SUBJ: **Addendum 1 – Clarifications to the Specifications and Responses to Vendor's Questions**

BID ITEM: **Bid Item #23-150 Construction - Airfield Electrical System Upgrade for Runways 5-23 & 11-29 for Augusta, GA – Daniel Field Airport**

ADDENDUM NO. 1

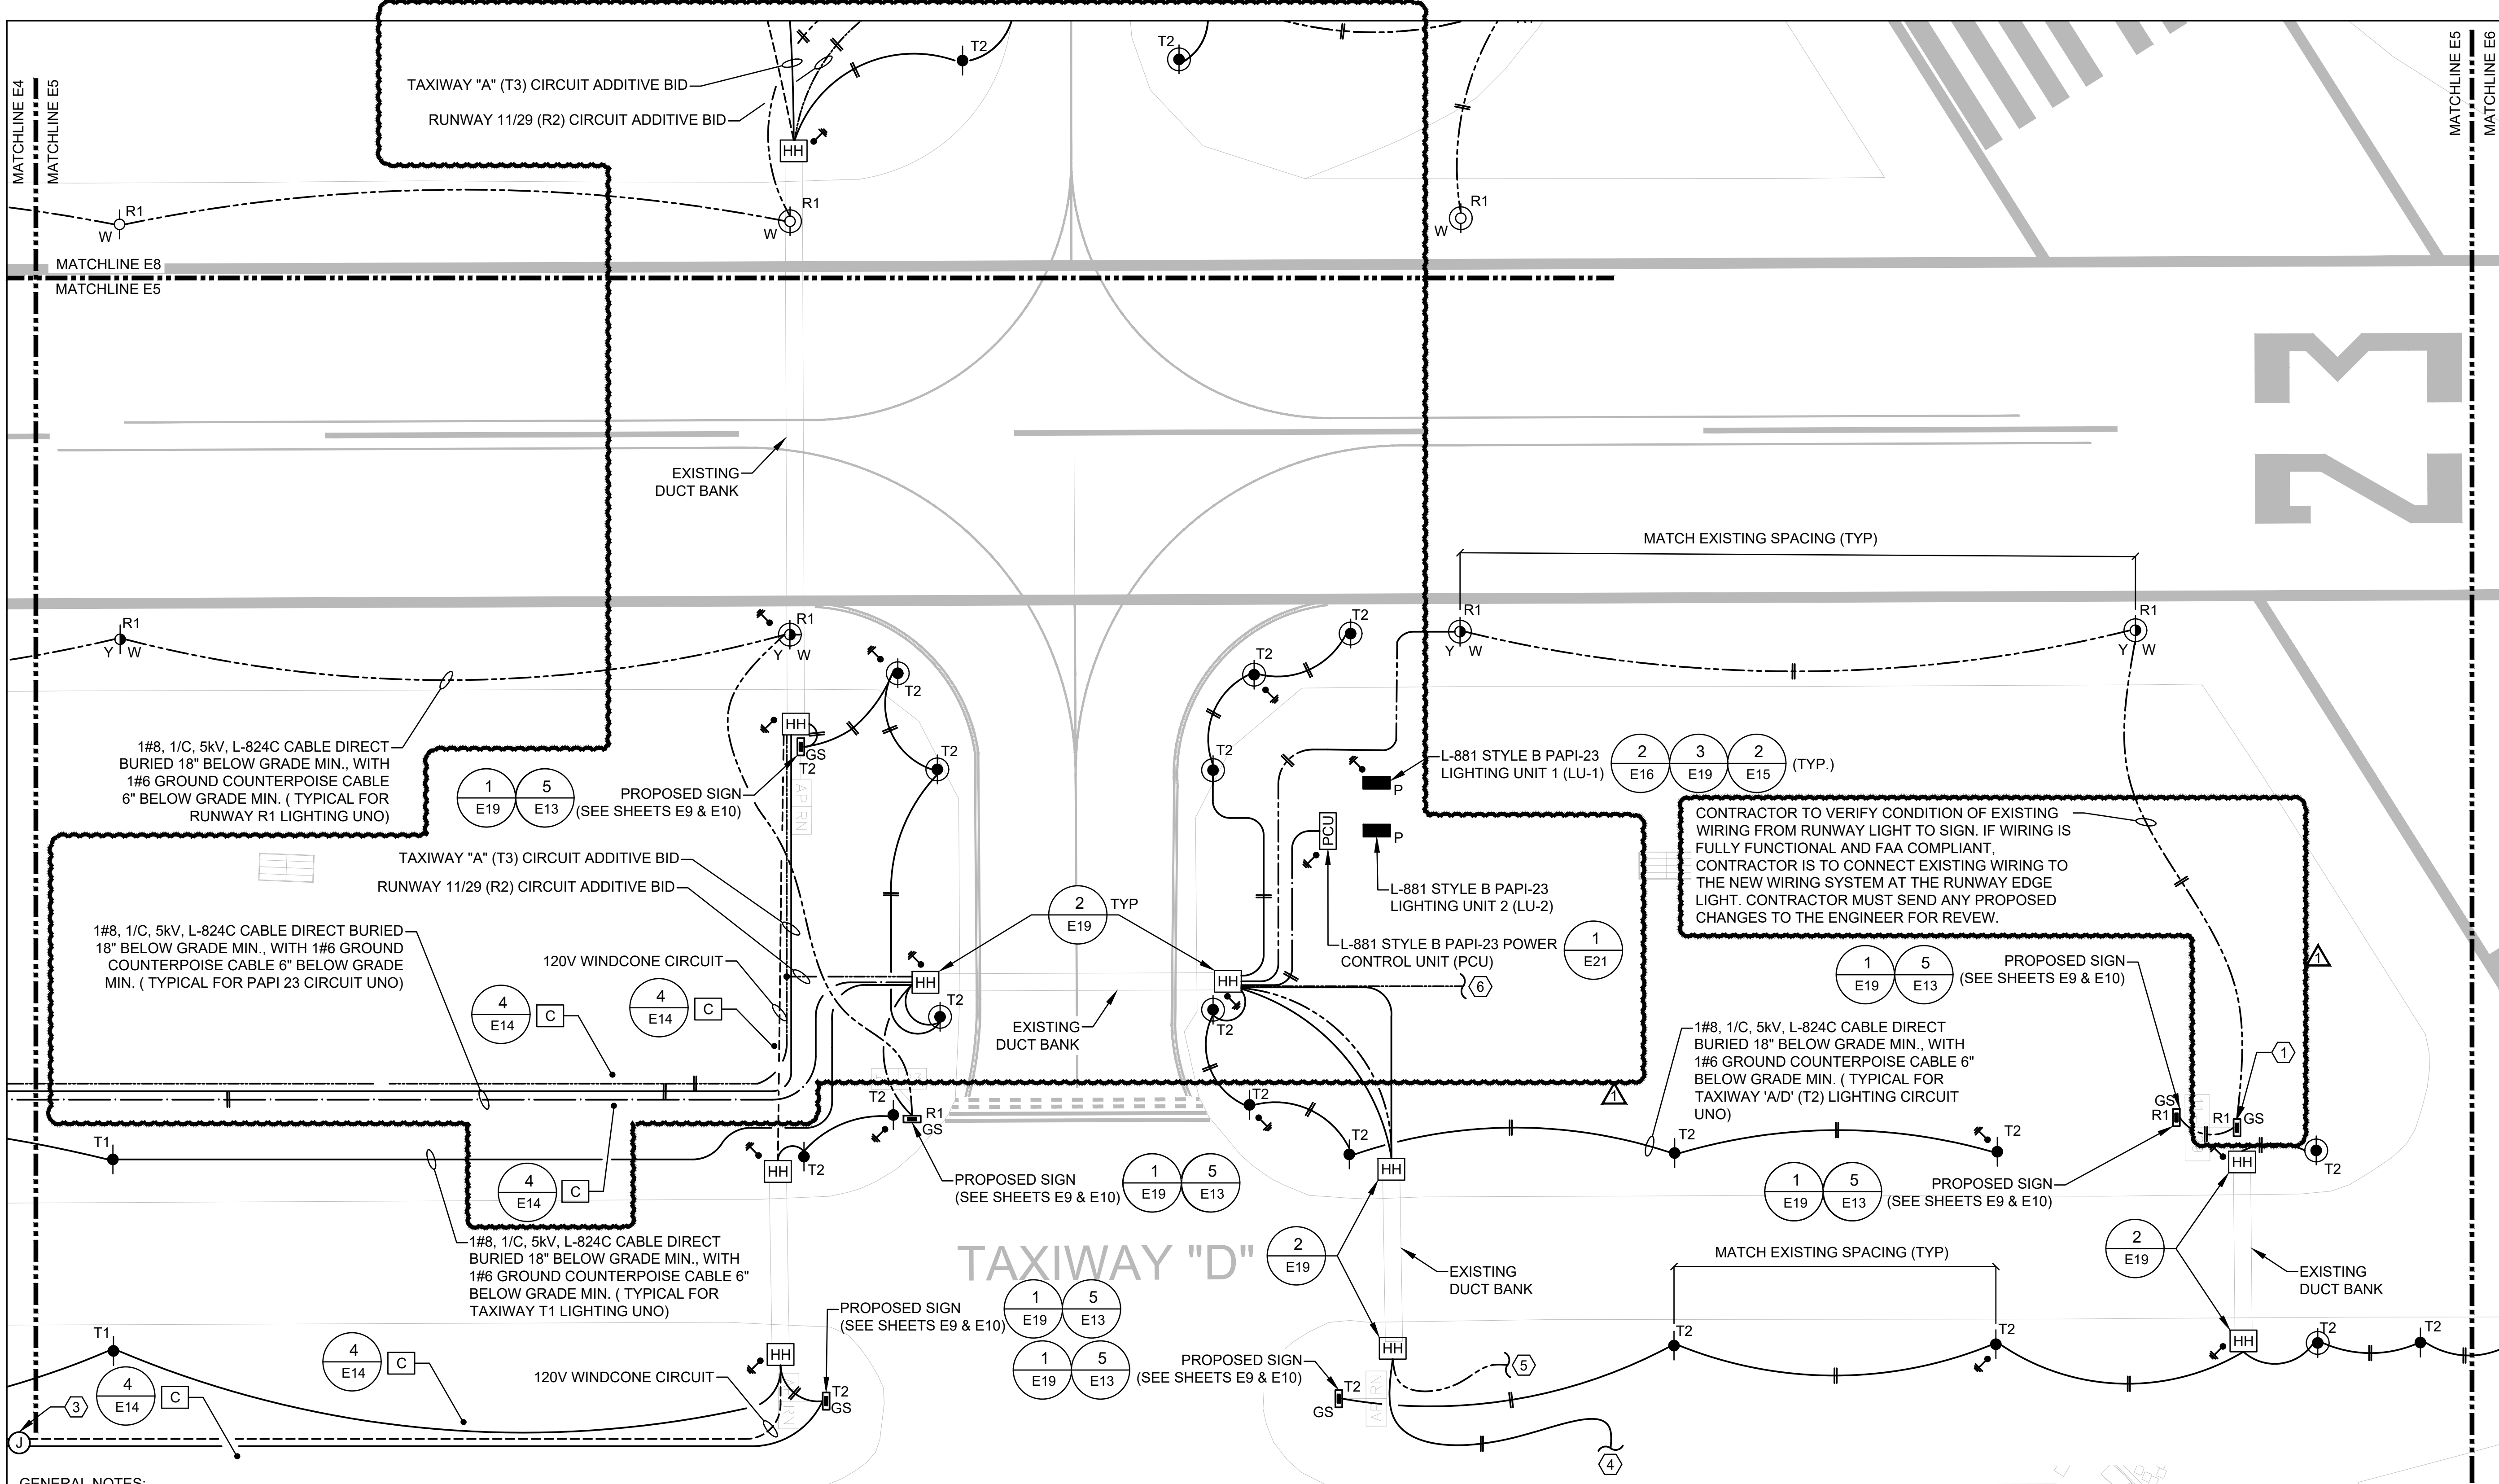
- O. **Replace Sheet E5** – Airfield Lighting & Wiring Plan – Runway 5/23 – Part 5 with revised Sheet E5 attached to this Addendum 1.
- Scale of this sheet revised from 1"=50' to 1"=25'.

- Deleted all Field Lightning Arrestors.
 - Revised Keynote 1 revised to state Existing Sign to remain. Connect to new wiring system as required.
 - Mandatory Sign 5-23 (S14) revised from being replaced to existing to remain.

- Runway 11/29 (Additive Bid) & Taxiway A (Additive Bid) routing of wiring shown back to vault.
 - Added Conduit markers for Runway 11/29 & Taxiway A Circuits.

- Added Keynote 6.
- P. **Replace Sheet E6** – Airfield Lighting & Wiring Plan – Runway 5/23 – Part 6 with revised Sheet E6 attached to this Addendum 1.

AIRFIELD LIGHTING & WIRING PLAN - RUNWAY 5/23 - PART 6
 SCALE: 1"=50'-0"

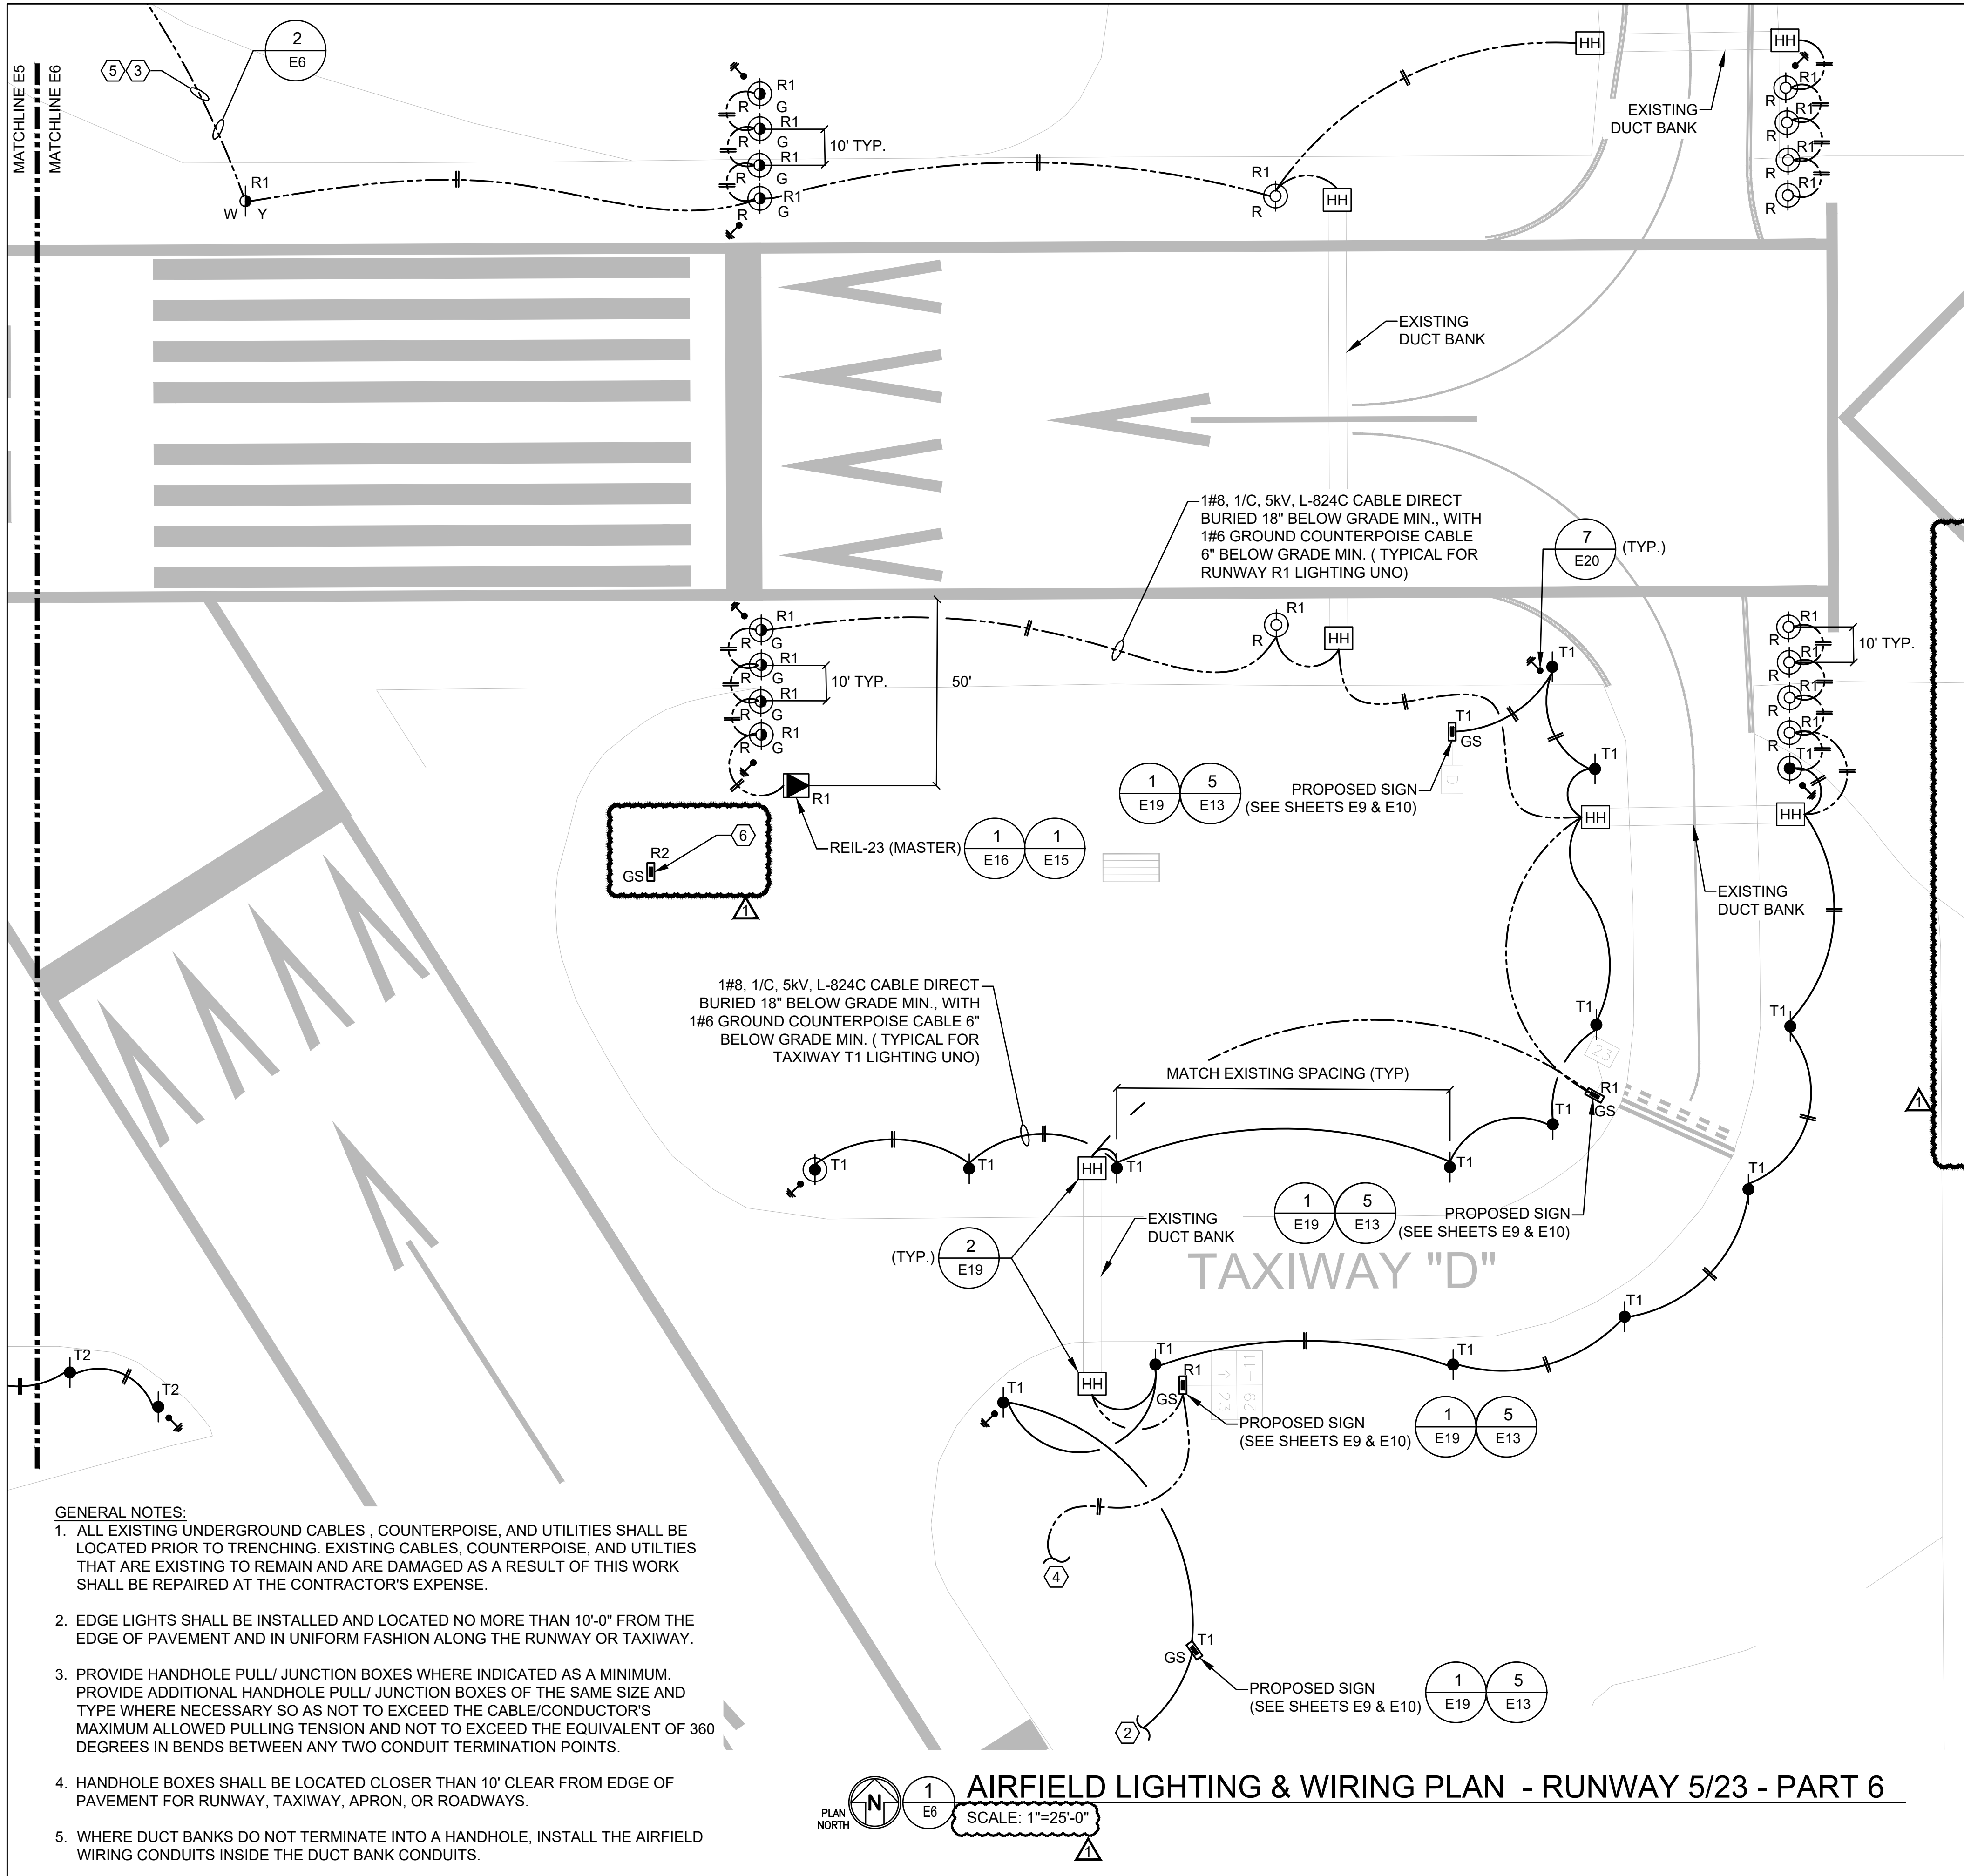
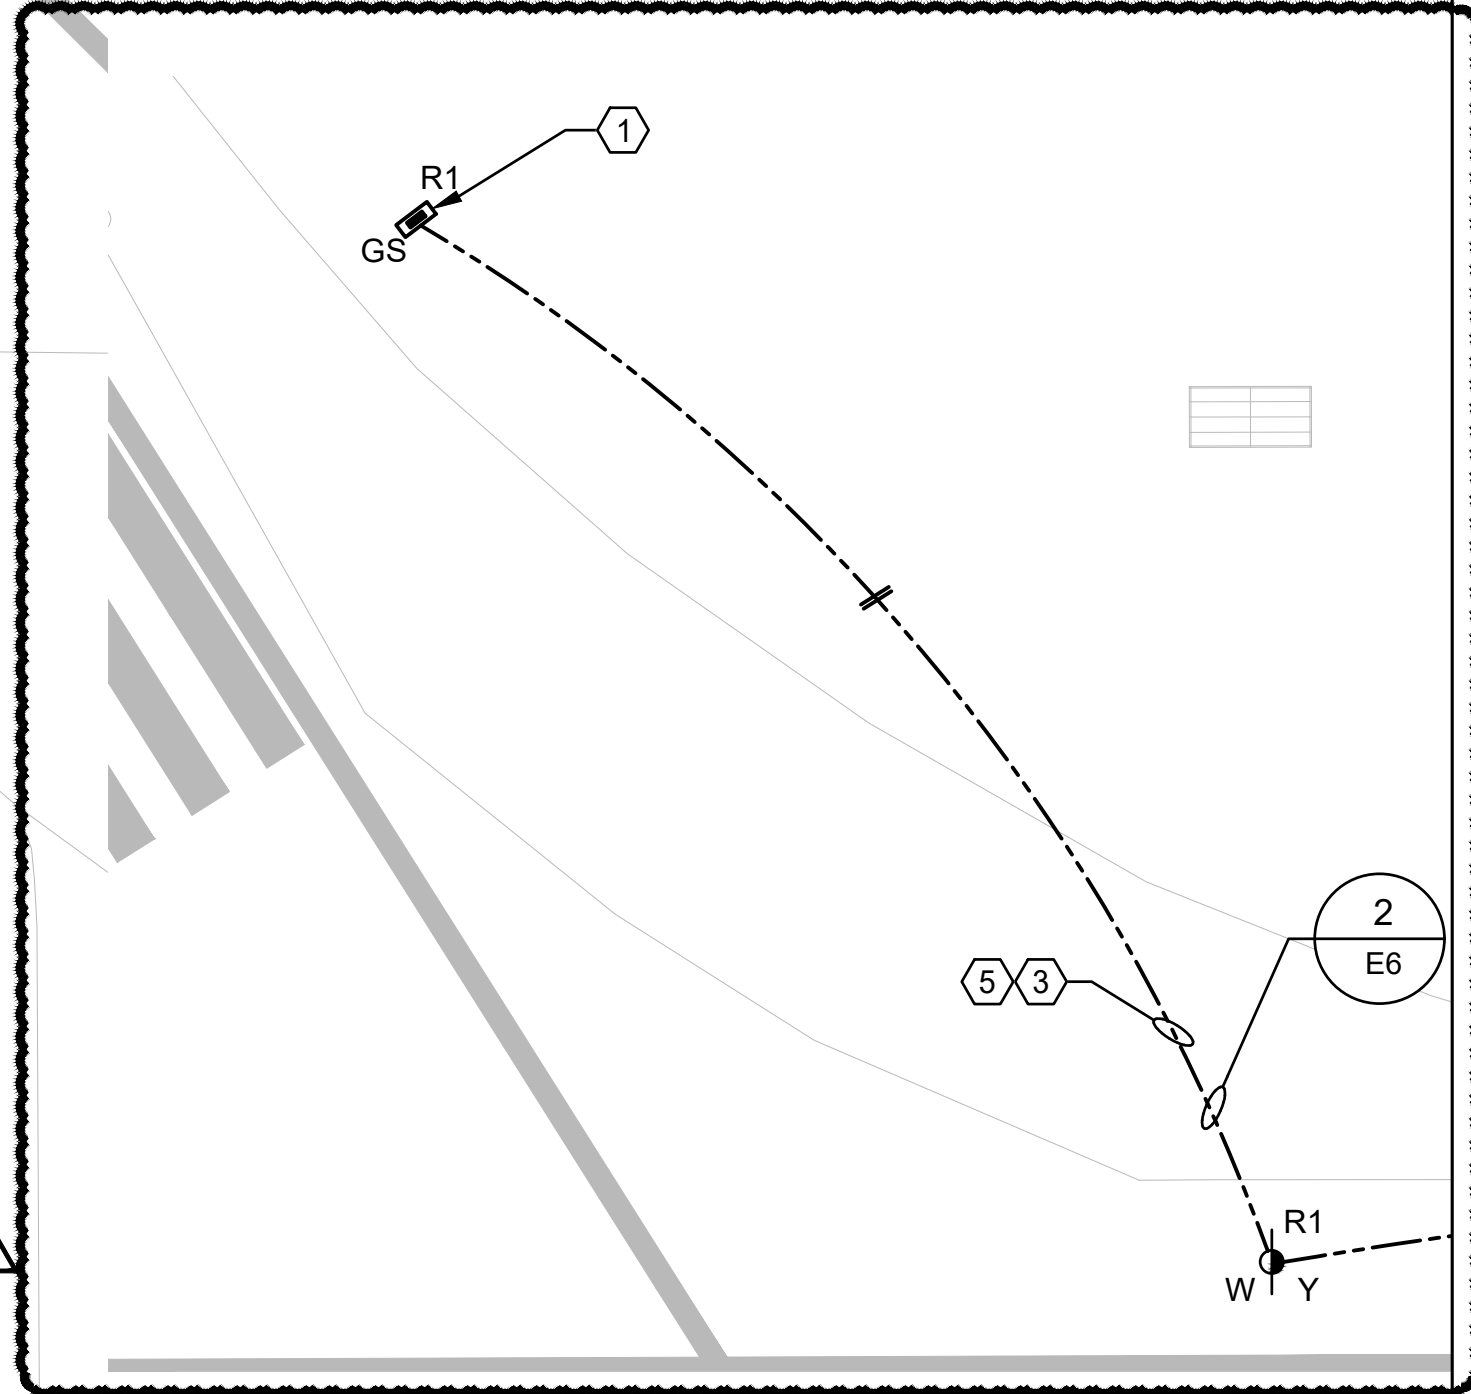
- Scale of this sheet revised from 1"=50' to 1"=25'.
 - Deleted all Field Lightning Arrestors.
 - Revised Keynote 1 revised to state Existing Sign to remain. Connect to new wiring system as required.

- Mandatory Signs 29-11 & 23-5 (S16 & S21) revised from being replaced to existing to remain. Mandatory sign 29-11 revised from Taxiway T1 Circuit to Runway 11/29 R2 (Additive Bid) Circuit.

- Added Keynote 5 & 6.
- Q. **Replace Sheet E7** – Airfield Lighting & Wiring Plan – Runway 5/23 – Part 7 with revised Sheet E7 attached to this Addendum 1.
